Access Compliance Report

Public Rights-of-Way

(Curb Ramps)

Intersection ID: 28050	Main Street: TENENCIA_CT	Cross Street: WILLOW_ROCK_DR	Location: S
ADA ID: 2547D377D958	Ramp Type: PerpDiag	Initial Pass/Fail: Fail	Overall Compliance: No
Severity Score: 10			
Codes/Mitigation Info/Possible Solution		Field Measurements/Component Compliance

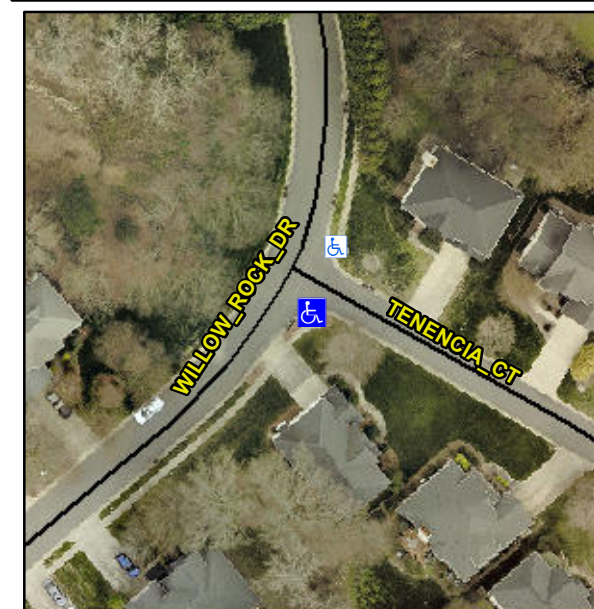
R304.5.1, R304.5.3

Compliance	Description	Data	Compliance	Description	Data
N/A	Ramp Length (in)	53.0	Yes	Ramp Slope (%)	5.5
No	Ramp Width (in)	40.0	No	Ramp XSlope (%)	4.1
N/A	Flare Type LT	N/A	N/A	Flare Type RT	N/A
N/A	Flare Slope LT (%)	N/A	N/A	Flare Slope RT (%)	N/A
N/A	Flare Traversable LT?	N/A	N/A	Flare Traversable RT?	N/A
N/A	Landing Length (in)	N/A	N/A	DWS Provided?	N/A
N/A	Landing Width (in)	N/A	N/A	DWS Contrast?	N/A
N/A	Landing Slope (%)	N/A	N/A	DWS Length (in)	N/A
N/A	Landing X Slope (%)	N/A	N/A	DWS Full Width?	N/A
N/A	Landing Curb? (Y/N)	N/A	N/A	DWS Offset (in)	N/A
N/A	Shared Landing?	N/A			
N/A	Gutter Ponding?	N/A	N/A	Gutter Slope (%)	N/A
N/A	Gutter Lip Ht (in)	N/A	N/A	Gutter X Slope (%)	N/A
N/A	Painted X Walk1?	No	N/A	Painted X Walk2?	No
	X Walk 1 Direction	To NE		X Walk 2 Direction	To NW
N/A	X Walk 1 Width (in)	N/A	N/A	X Walk 2 Width (in)	N/A
	X Walk 1 Slope (%)	0.7		X Walk 2 Slope (%)	0.1
	X Walk 1 X Slope (%)	2.7		X Walk 2 X Slope (%)	0.2

Remove & Replace Curb Ramp With Two New Directional Ramps or Equivalent.
